STATE OF UTAH
DEPARTMENT OF NATURAL RESOURCES
DIVISION OF OIL, GAS AND MINING

APPLICATION FOR PERMIT TO DRILL				5. MINERAL LEASE NO: ML-21577	6. SURFACE: State
1A. TYPE OF WORK: DRILL <input checked="" type="checkbox"/> REENTER <input type="checkbox"/> DEEPEN <input type="checkbox"/>				7. IF INDIAN, ALLOTTEE OR TRIBE NAME:

2. NAME OF OPERATOR: KERR MCGEE OIL & GAS ONSHORE L.P.				9. WELL NAME and NUMBER: STATE 1021-32M	
3. ADDRESS OF OPERATOR: 1368 S 1200 E CITY VERNAL STATE UT ZIP 84078			PHONE NUMBER: (435) 781-7024	10. FIELD AND POOL, OR WILDCAT: NATURAL BUTTES

**STATE 1021-32M
SW/SW SEC. 32, T10S, R21E
UINTAH COUNTY, UTAH
ML-21577**

APPROXIMATE TOTAL 10" PIPELINE DISTANCE = 3,300' +/-

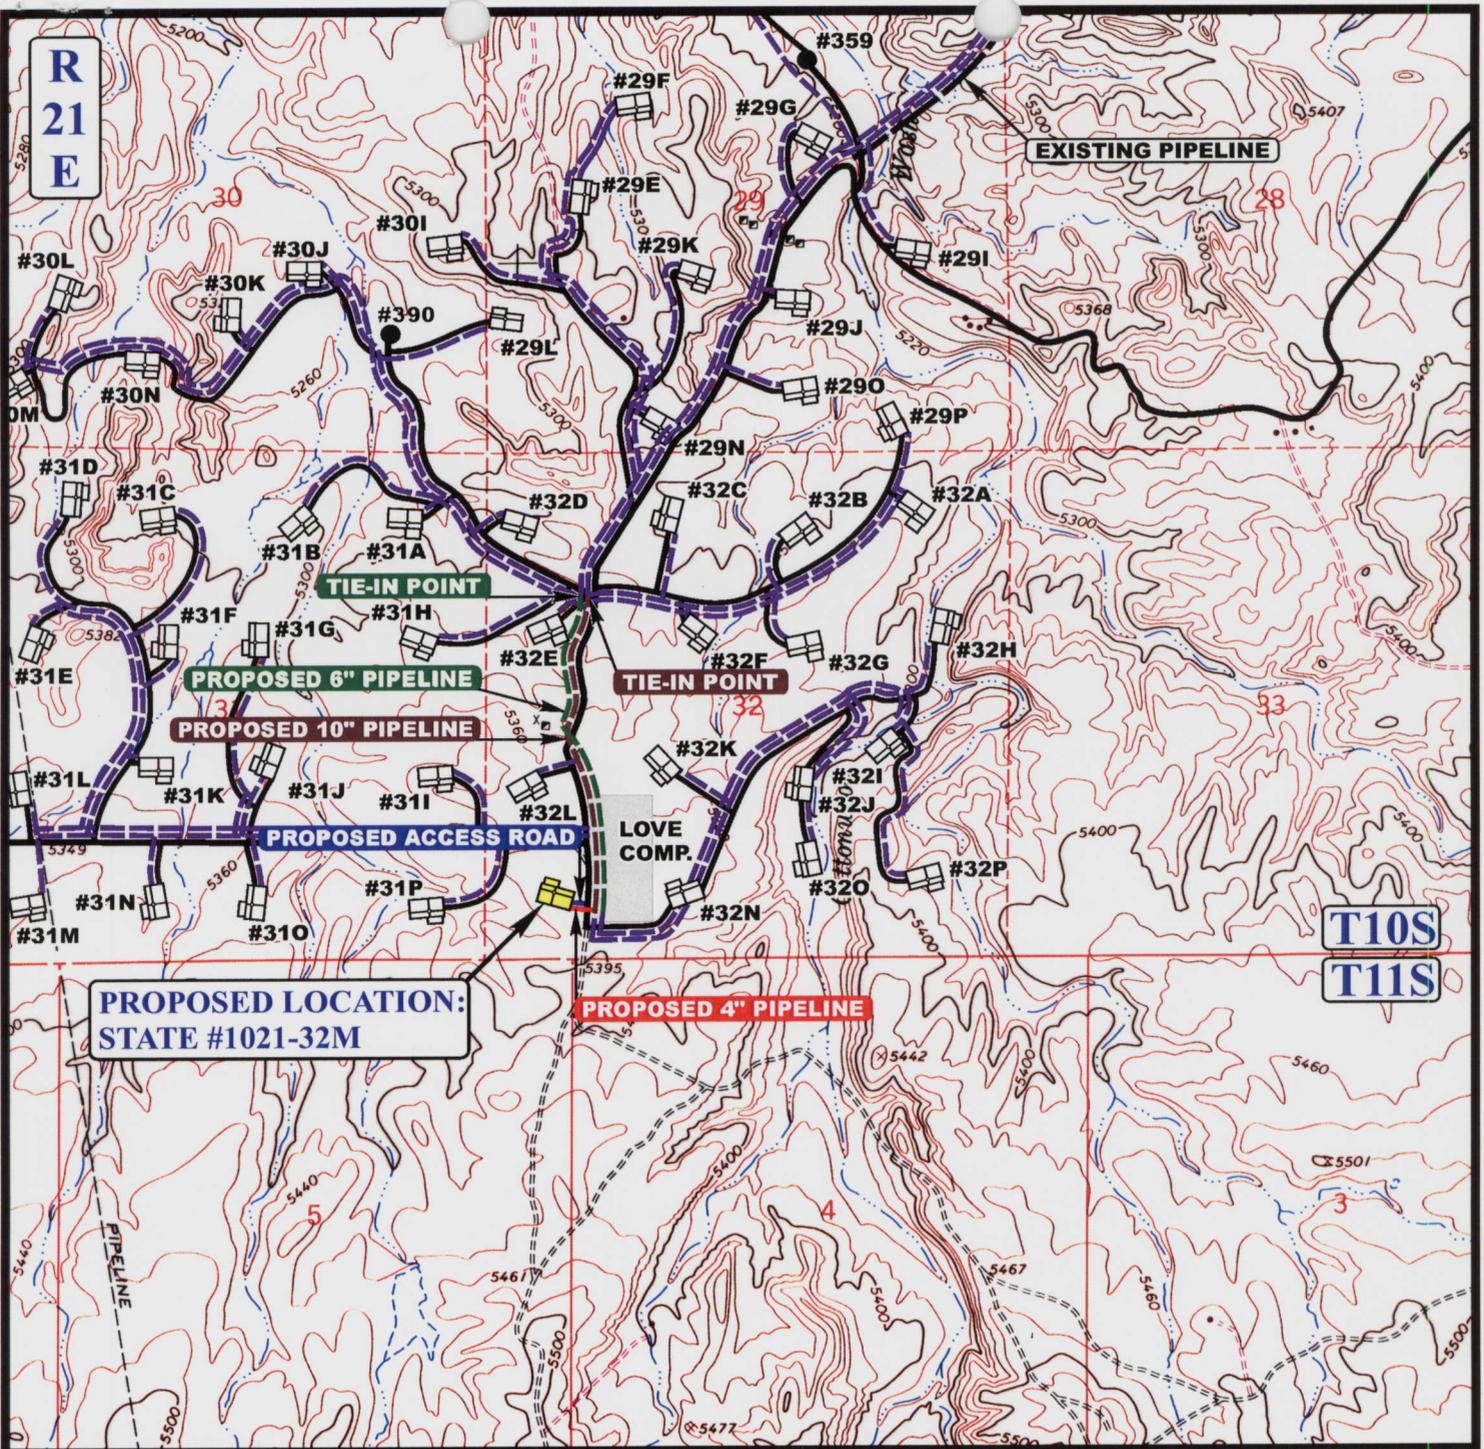
An onsite was conducted on 4/4/07 with the Division of Oil, Gas and Mining Representative and SITLA Representative. It was decided to change the proposed pipeline from a 4" pipeline that was approximately 186' +/- to, a 4" pipeline approximately 186' +/-, a 6" pipeline approximately 3,300' +/-, and a 10" pipeline approximately 3,300'
